## ITEM #3 - PRELIMINARY PLAT SHEPHERD SUBDIVISION

KPB File No.	2024-098
Plat Committee Meeting:	October 14, 2024
Applicant / Owner:	James & Mary Shepherd
Surveyor:	John Segesser / Segesser Surveys
General Location:	Tolum Road, Clam Gulch Area

#### STAFF REPORT

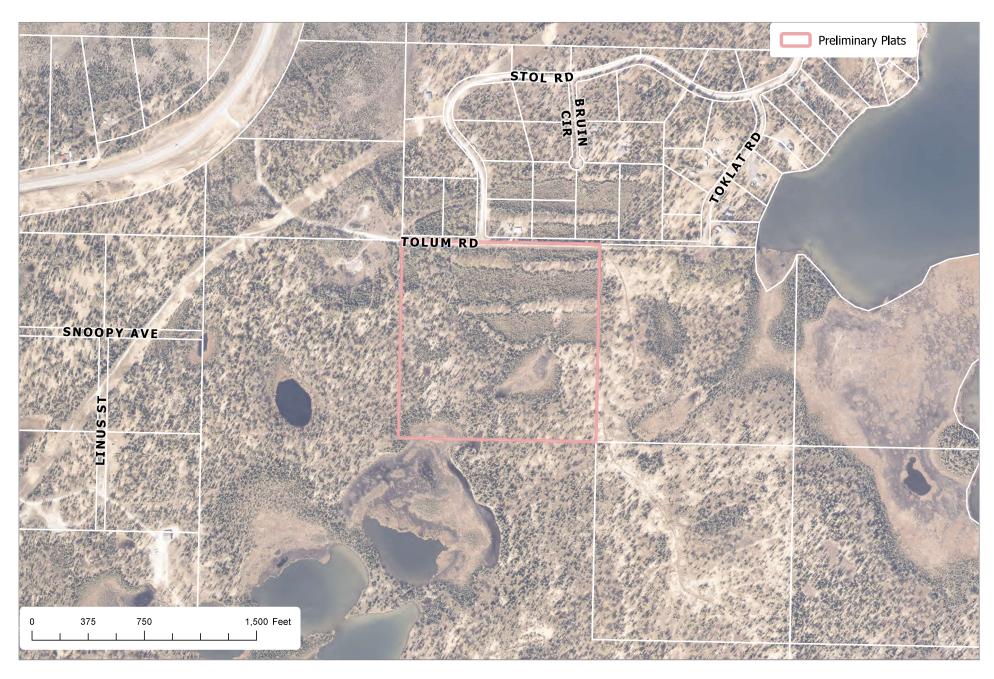
Staff recommends the surveyor add the other wetland areas to the map for the final submittal.

Staff recommends: The utility easement be delineated on the plat.

- Add the date of October 14, 2024 to the Plat Approval
- Show the 20' building setback on the drawing along with the 10' utility easement or add a typical detail.
- Add the KPB File number 2024-098 to the title block
- If the NW corner of the section is not found, it should be reset.

Stol Road and Tolum Road to the north are dedications and should be shown with a solid line.

Add Tolum Road and Stol Road to the vicinity map.

Wetlands should be shown on the plat. The Kettle area shown should be labeled, add depression per KWF Wetlands Assessment.

Wetlands

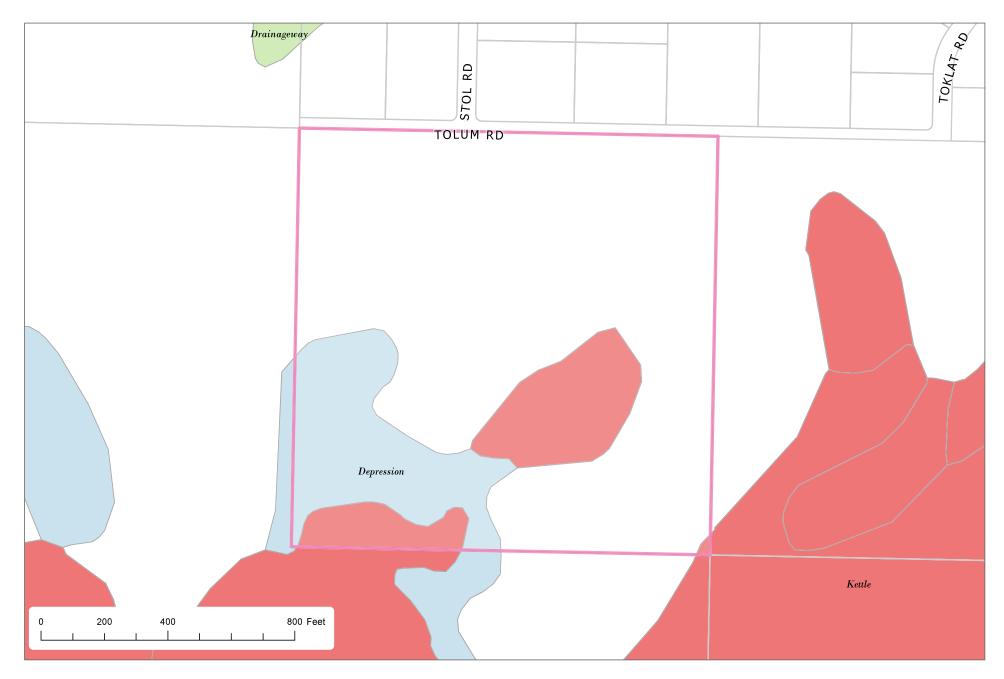
According to KWF Wetland Assessment Data, there are wetlands located on the property. The areas shown on the drawing as subject to inundation are identified as Kettle on the KWF Wetlands Assessment map. There are also

areas of depression to the west and between the kettle areas. The River Center review did not identify the plat to be in a DEMA identified flood hazard zone or a habitat protection area.
